The City of New York

The City of New York's Comments on the Proposed Plan for the Gowanus Canal Superfund Site

April 26, 2013

Figure 2-2b

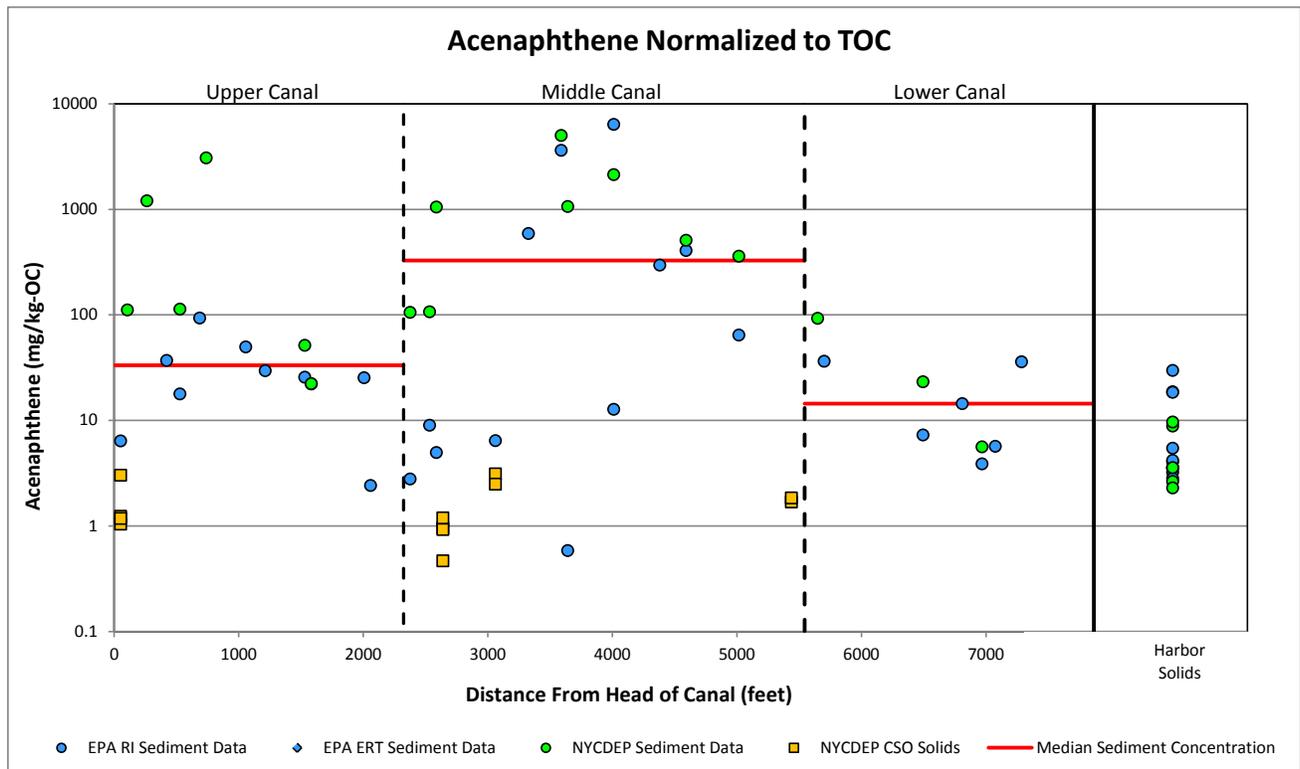
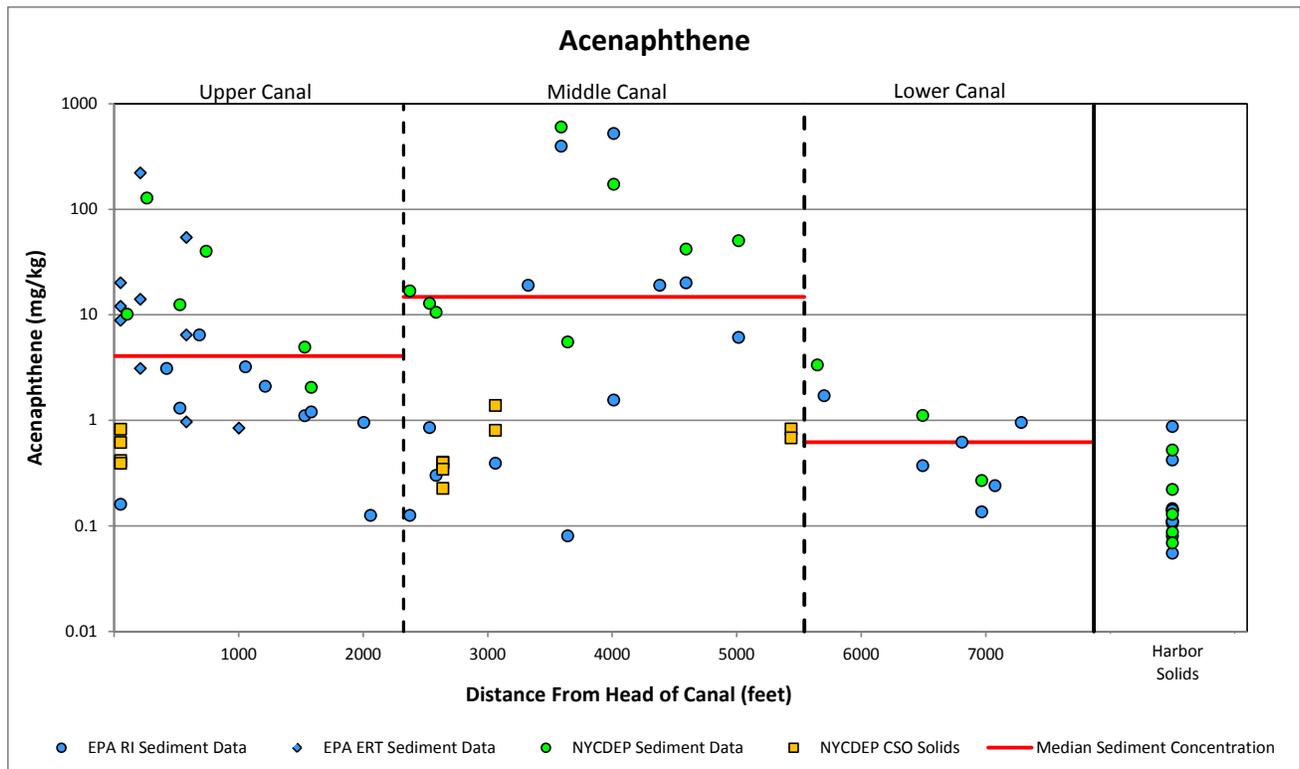
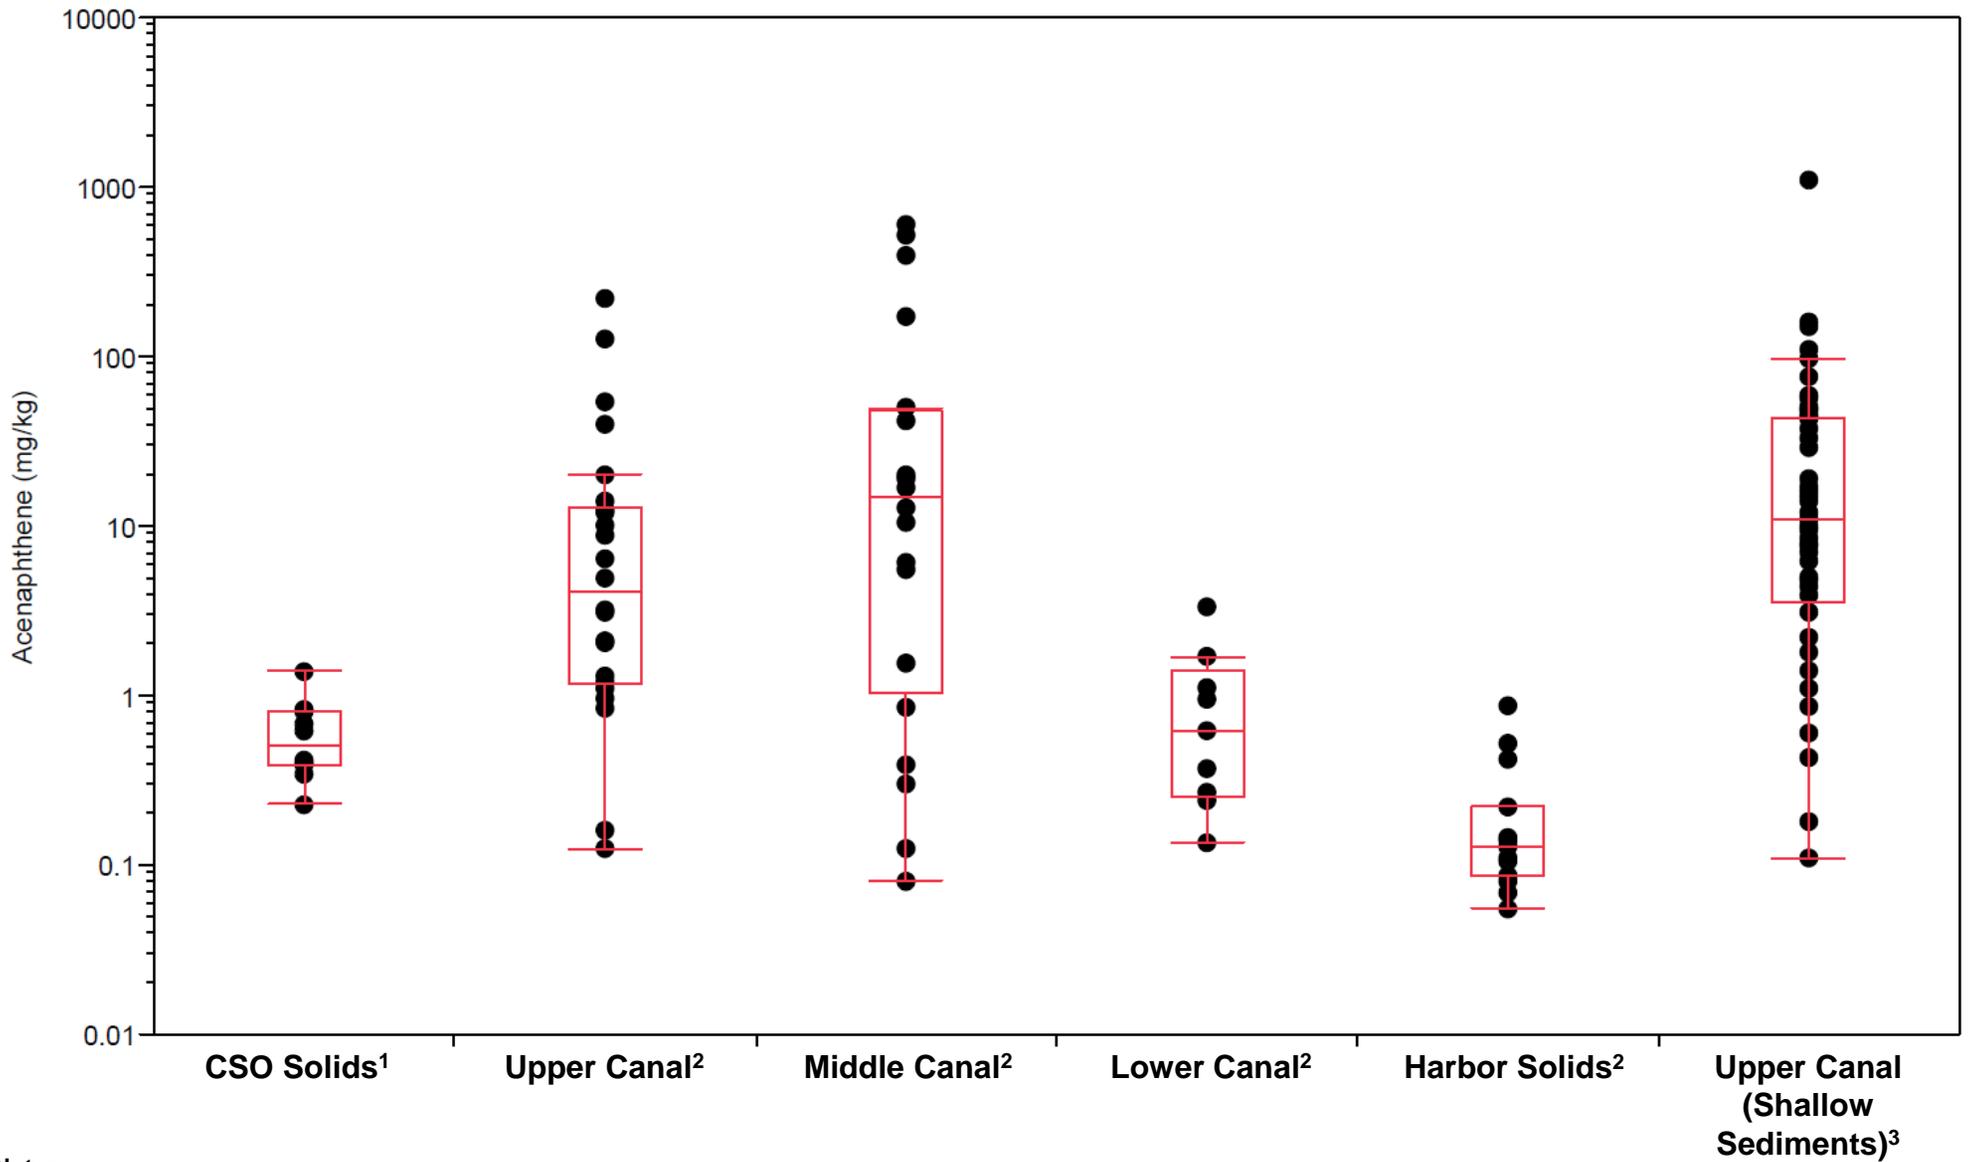
- In shallow sediments (0 to 2 feet), concentrations of TPAH, which average 490 mg/kg, are higher than TPAH in CSO solids (see Figure 2-2b). Similar patterns exist for acenaphthene, benzo(b)fluoranthene, benzo(k)fluoranthene, and phenanthrene in shallow sediments in the Upper Canal relative to CSO solids (see Figures 2-3b to 2-6b). This observation is contrary to the assertion in the FS Addendum that CSOs are responsible for TPAH contamination in shallow sediments.

Figure 2-7b

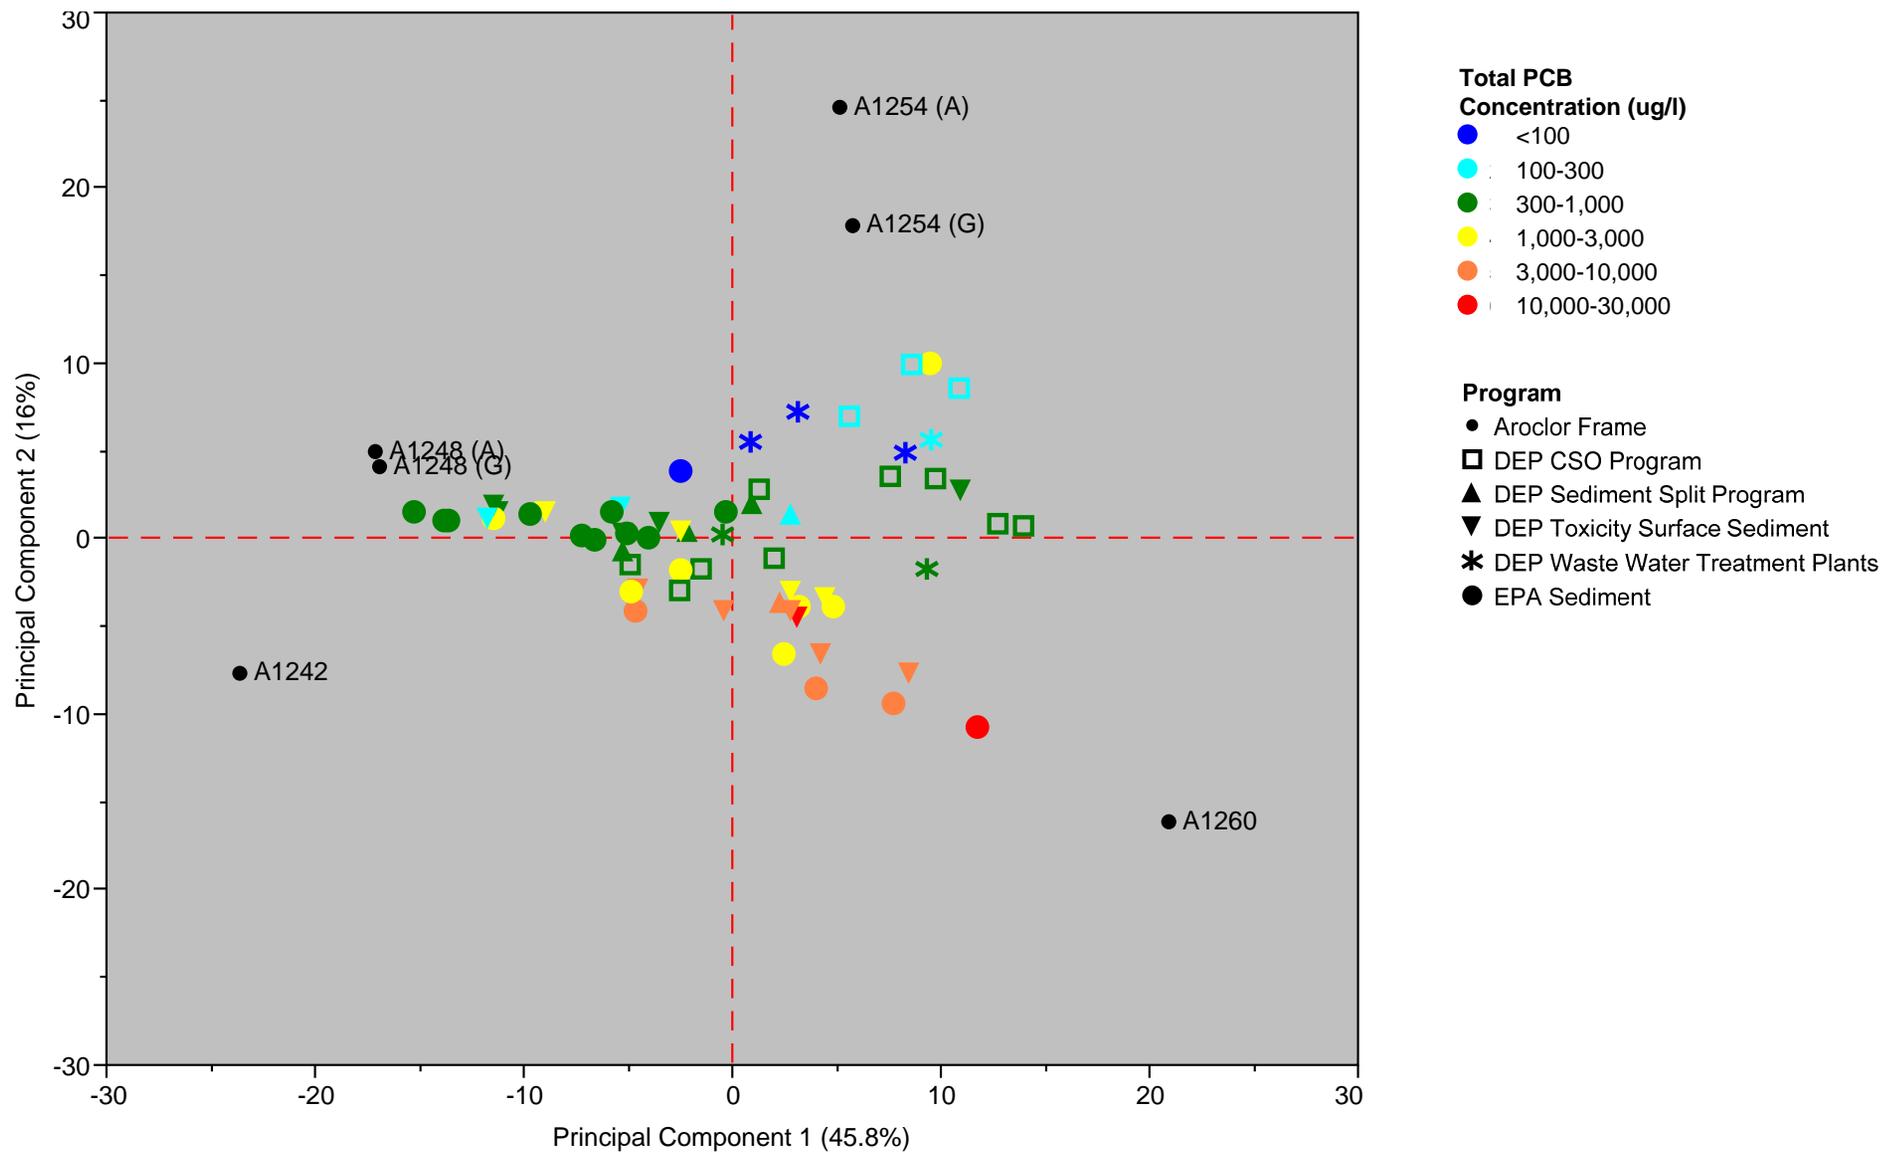
- In shallow sediments (0 to 2 feet), concentrations of TPCB, which average 3 mg/kg, are higher than TPCB in CSO solids (see Figure 2-7b). This observation is contrary to the assertion in the FS Addendum that CSOs are responsible for TPAH contamination in shallow sediments.

Figure 2-9a

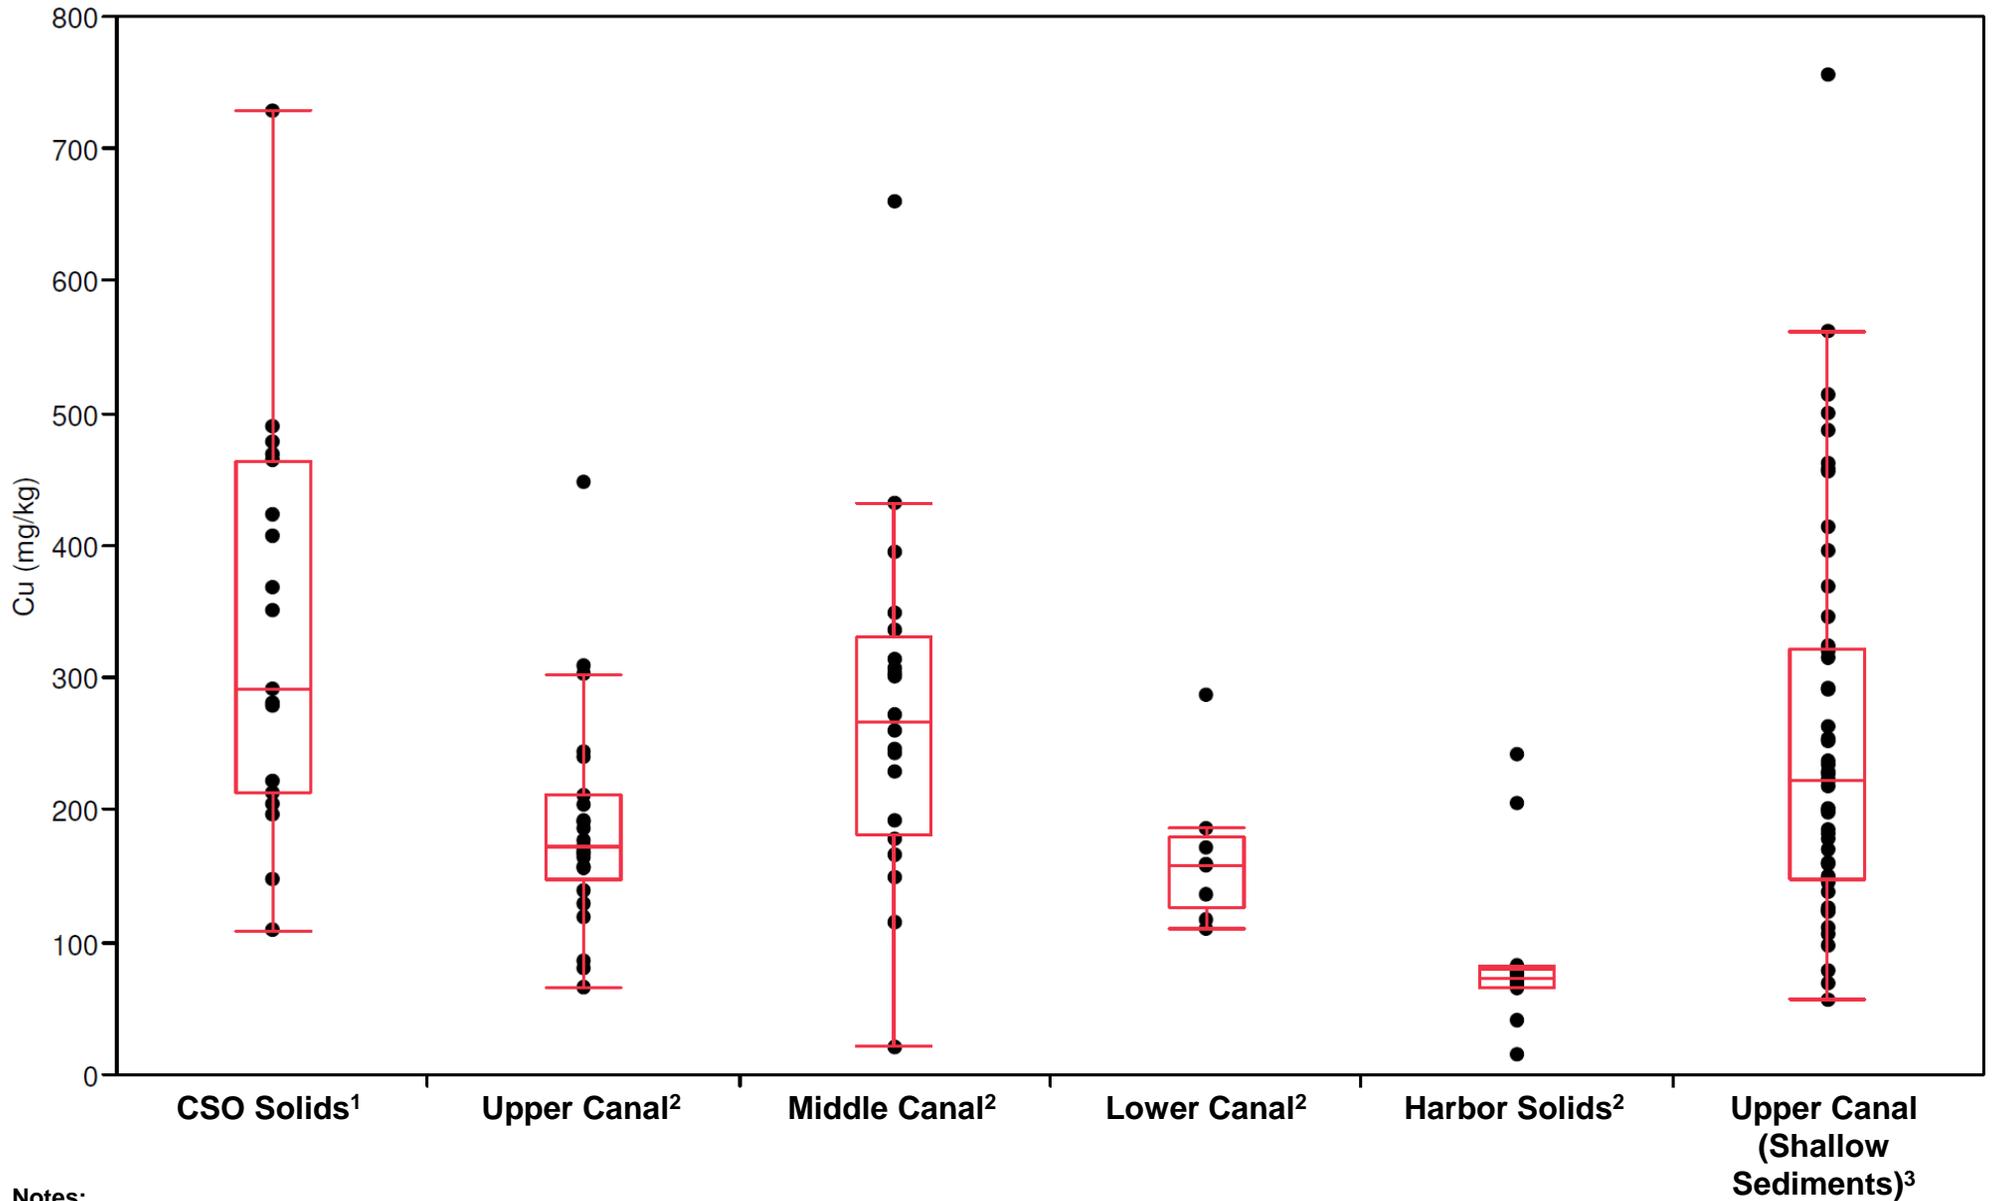
- CSO solids contribute substantially higher copper concentrations (average of 300 mg/kg) to the Upper Canal, but these solids must be significantly diluted by cleaner sediments to achieve an average concentration of 190 mg/kg in the Upper Canal surface sediments and 220 mg/kg in the Upper Canal shallow sediments (see Figure 2-9). This dilution is more pronounced when copper is normalized to aluminum (see Figure 2-9a).

Figure 2-11

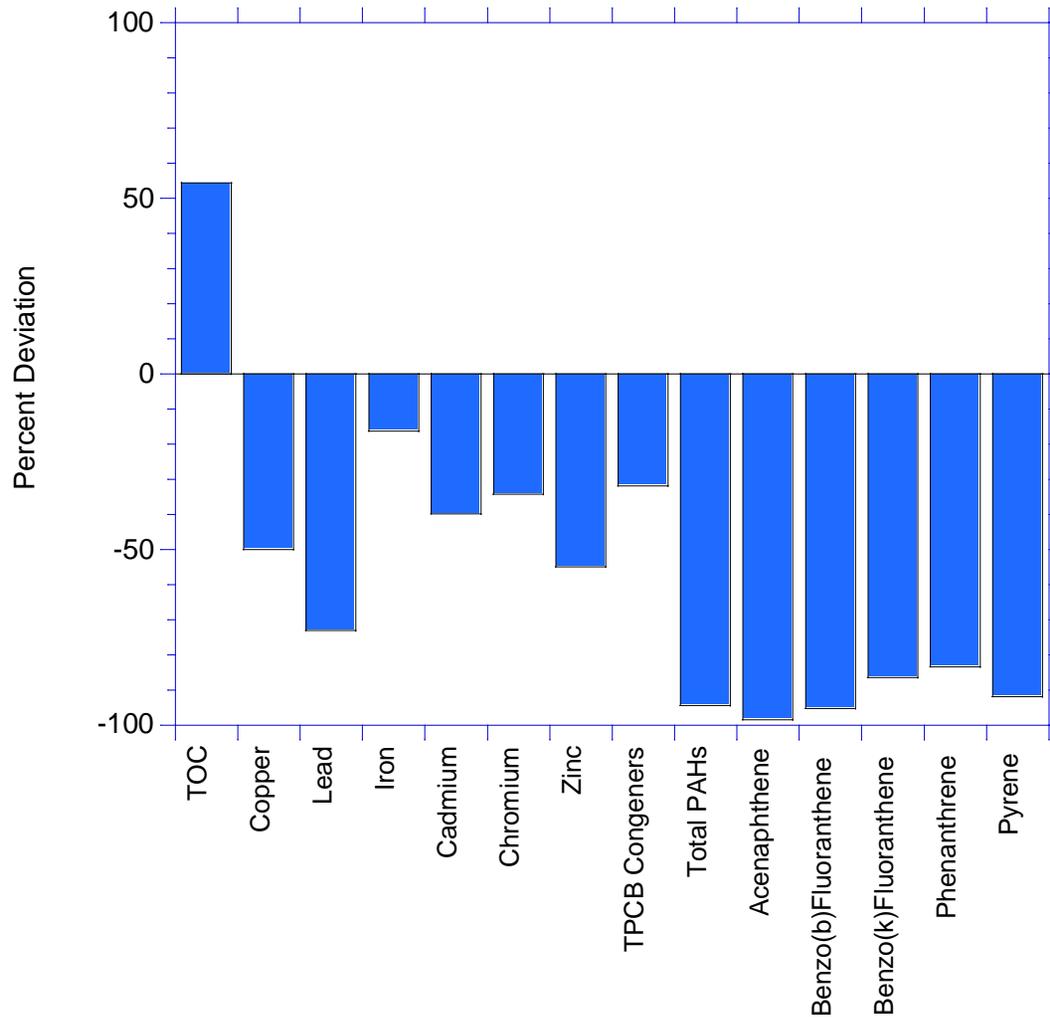
- The likelihood of another source of lead was further explored by looking at the multivariate relationship amongst lead, copper and aluminum for the CSO solids, the reference area sediments and sediments in the Canal. Figure 2-11 presents
